PROJECT NAME	Lincolnshire Lakes, Phase 1		
DOCUMENT NUMBER	LLP1-BWB-GEN-XX-RP-TR-0009	BWB REF	221638.00
AUTHOR	J. Lindsay	STATUS	S2
CHECKED	M. Corner	REVISION	P03
APPROVED	J. Lindsay	DATE	22.01.26

- 1.1 This Technical Note (TN) has been prepared to address Active Travel England's (ATE) latest consultation response to planning application reference PA/2025/254 (550 dwelling development at Lincolnshire Lakes), dated 22nd December 2025.
- 1.2 A copy of ATE's latest consultation response can be found at **Appendix 1**.
- 1.3 It is noted that ATE's latest consultation response refers to outstanding queries raised in their previous response dated 1st October 2025. A copy of this response can be found at **Appendix 2**.
- 1.4 The following section of this TN set's out BWB's response to the outstanding items raised by ATE.

Active Travel England Planning Response Detailed Response to an Application for Planning Permission

Figure 1: Connection with M181 Roundabout

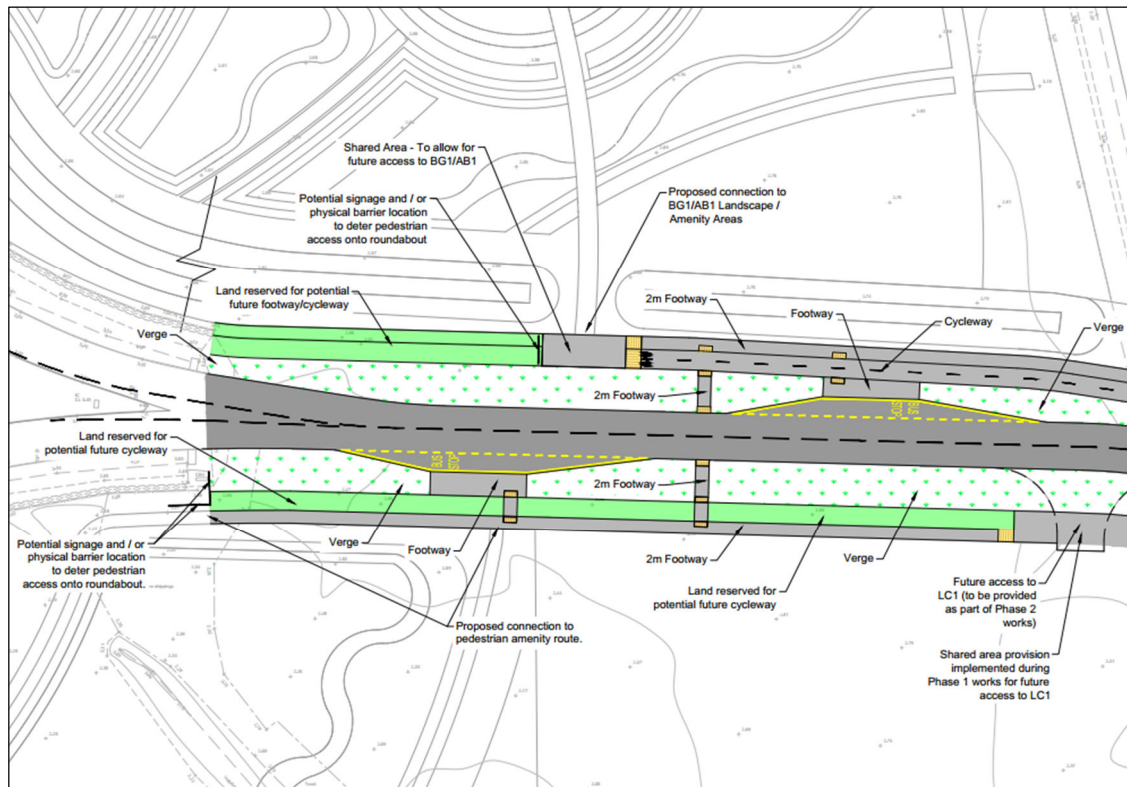
"The primary vehicular access is via the existing M181 roundabout. Clarification was requested regarding what measures will be put in place to prevent pedestrians and cyclists from attempting to leave the site via this route. It has not been possible to identify a response on this matter, which therefore remains outstanding."

- 2.2 Active travel infrastructure has been designed that restricts active travel connectivity to no further west than required, as illustrated in **Figure 1** (i.e. footway and cycleway provision provided up to the bus stops on the northern side of the carriageway, and a footway connection with the trim trail walk on the southern side of the carriageway).

- 2.3 Physical barriers (such as guard railing or planting) and / or signage could be introduced at the end of the footway/cycleway, if required (as illustrated in **Figure 1**), to further deter pedestrians and cyclists from travelling over the verge towards the roundabout carriageway. The Section 38 process will set out how non-motorised user provision to the west will be restricted.
